# TECHNICAL NOTE

| Project     | Site A Willow Way, Sydenham                  |                           | Project No. | 22/089  |             |
| Subject     | Technical Note in Support of Planning Appeal |                           | Document No | TN004   |             |

**Table 1-1: LBL Officer Report Comments on the Application and VTP Response**

PLAN SHOWING PARKING CAPACITY LOST BY PROPOSED DOUBLE YELLOW LINES

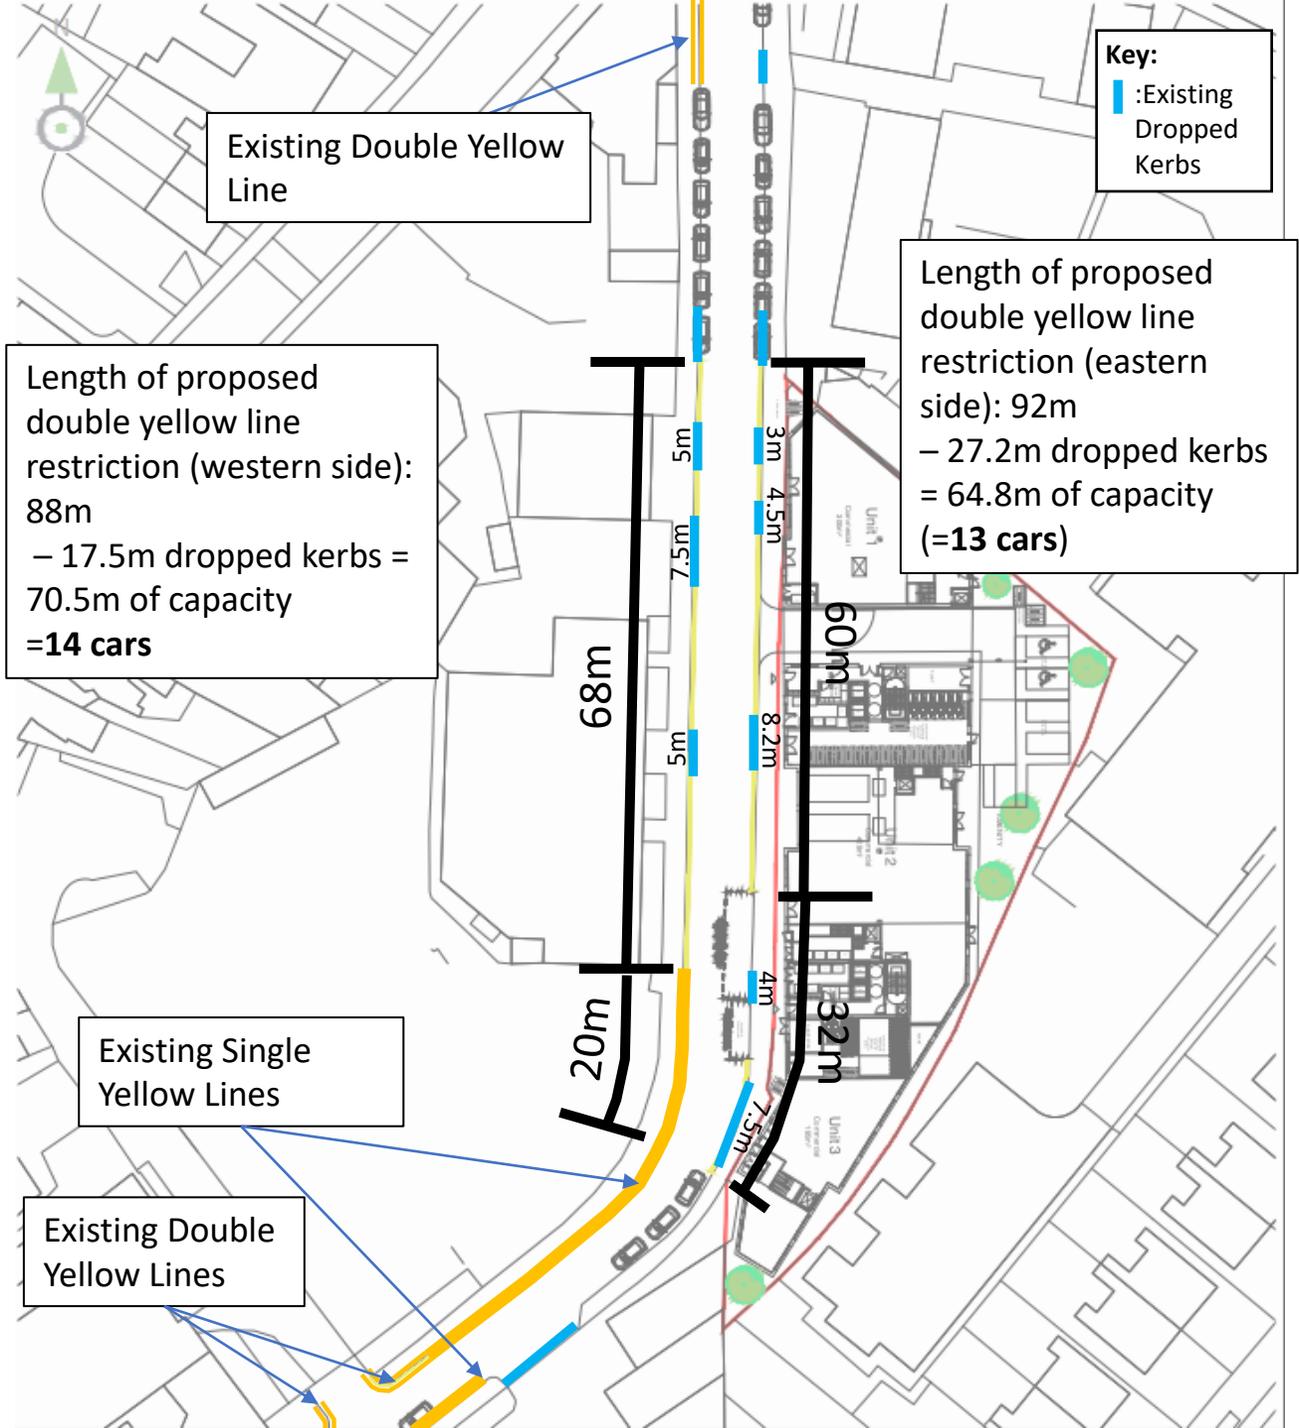
| PARAGRAPH | PLANNING OFFICER / LBL HIGHWAYS COMMENT  | VTP RESPONSE  |
|-----------|--|---|
| 295       | <p><b>Trip Generation:</b><br/>The Highways officer notes that: The selected TRICS sites are considered acceptable, and the expected overall net additional trips associated with the proposals have been assessed and are generally acceptable. The adjustments made to accommodate a car free site should not be adjusted but be accounted for as potential overspill parking and therefore the TA will need to be updated.</p>  | <p>Given that the London Plan parking requirements for a scheme in this location, would generally be car-free, with on-site parking limited to blue badge holders only and the existing on-street parking along Willow Way becoming restricted through the introduction of double yellow lines, it is reasonable to assume that for future occupiers of this site, owning a car would be inconvenient and therefore the vast majority of future residents will not own cars.</p> <p>A sensitivity test has nevertheless been provided later in this document (under paragraphs 323) of the potential overspill parking that could take place if residents owned and parked cars in the vicinity of the site in line with Census data. It must be noted that due to the pandemic (2020 – 2022), the 2011 Census Data has been referenced, which did not account for the current parking requirements for new developments in London.</p> <p>Furthermore, should a controlled parking zone come forward in the local area in future, a clause in the contract of the proposed development’s residential units could prevent residents from being eligible to obtain parking permits in the future. See <b>APPENDIX E</b>.</p> |

| PARAGRAPH | PLANNING OFFICER / LBL HIGHWAYS COMMENT  | VTP RESPONSE  |
|-----------|--|---|
| 323       | <p><b>Adjustment of Residential Trip Generation &amp; Parking Demand:</b><br/>The 2011 census data clearly shows that there is a potential that 12% of occupants of the residential units may drive and therefore will own a car which equates to 12 car parking spaces. The applicant adjusted this to 3% in line with the current London Plan policy requirements for the car-free nature of the site.</p> <p>The surveys indicate a spare capacity of 31 spaces on unrestricted parking spaces which would indicate sufficient capacity, but it should be noted the assessment of single yellow line and double yellow line parking availability is considered as restricted parking and not appropriate for this assessment.</p> | <p>It is noted that the 2011 census data suggests 21% of households may drive to work (not 12%) which could in theory forecast demand for 12 parking spaces. As noted by LBL, the parking survey demonstrates that there were 31 and 29 spaces available at the time of the Tuesday and Wednesday survey respectively along Willow Way. As shown in the raw data, single and double yellow lines were not included as unrestricted parking spaces and so the capacity for 31 and 29 extra vehicles does not take the single yellow line areas into account which could legally be parked on outside controlled hours. The analysis is therefore considered to be correct and robust.</p> <p><b>Parking sensitivity test for 12 resident vehicles</b><br/>While it is considered unlikely that the site will generate demand for 12 parking spaces, particularly in the context of current policy (and not that which would have been associated with the 2011 census data) should this level of demand have occurred during the parking survey and all 12 vehicles parked on Willow Way, there would have remained 19 and 17 parking spaces available over night during the survey period (plus the capacity of the single yellow line areas which can legally be parked in between 18:30 and 08:00). This parking demand on Willow Way would have equated to 49% on Tuesday and 54% on Wednesday which is far lower than the 80% typically considered to represent parking stress. This scenario also assumes that none of the 12 drivers had blue badges and therefore wouldn't have been able to park in one of the two on-site parking spaces provided from the outset of development.</p> <p>Double yellow line parking restrictions along Willow Way are proposed in order to control demand for parking and protect site user amenity. The following assessment demonstrates that the impact of the 12 vehicles would have taken account of the proposed double yellow line restrictions.</p> <p>Excluding dropped kerbs, the length of kerbside space proposed to have double yellow line restrictions amounts to approximately 70.5m of capacity on the western side of Willow Way, and 64.8m of capacity on the eastern side as shown in the plan in <b>APPENDIX E</b> of this Technical Note. Based on an average car length of 5m, this suggests the western side currently has capacity for up to 14 cars to park, and up to 13 cars on the eastern side. 20m of the western side already has single yellow line</p> |

| PARAGRAPH | PLANNING OFFICER / LBL HIGHWAYS COMMENT   | VTP RESPONSE   |
|-----------|---|--|
|           |   | <p>As calculated earlier, the western side of Willow Way subject to the proposed double yellow line restrictions would reduce the parking capacity by 10 vehicles.</p> <p>Assuming a maximum of 10 vehicles are displaced from the western side of Willow Way to the surrounding streets within 500m of the site (which is also the area covered by the parking survey), the parking occupancy in the survey area would increase from 49% to 53% based on the Tuesday survey demand, and from 54% to 57% based on the Wednesday survey demand. This includes two vehicles which were parked on the eastern side of Willow Way outside of the proposed double yellow line restricted area on both nights of the survey.</p> <p>In the event that the site generated 12 resident vehicles which also parked in the survey area, the overall occupancy would increase to 74% on the Tuesday and 78% on the Wednesday.</p> <p>It is therefore reasonable to assume that the drivers of the vehicles which have historically parked on the western side of Willow Way would be able to find an alternative parking space within the survey area if needed, with a maximum walking time of 5 minutes from the site.</p>                      |
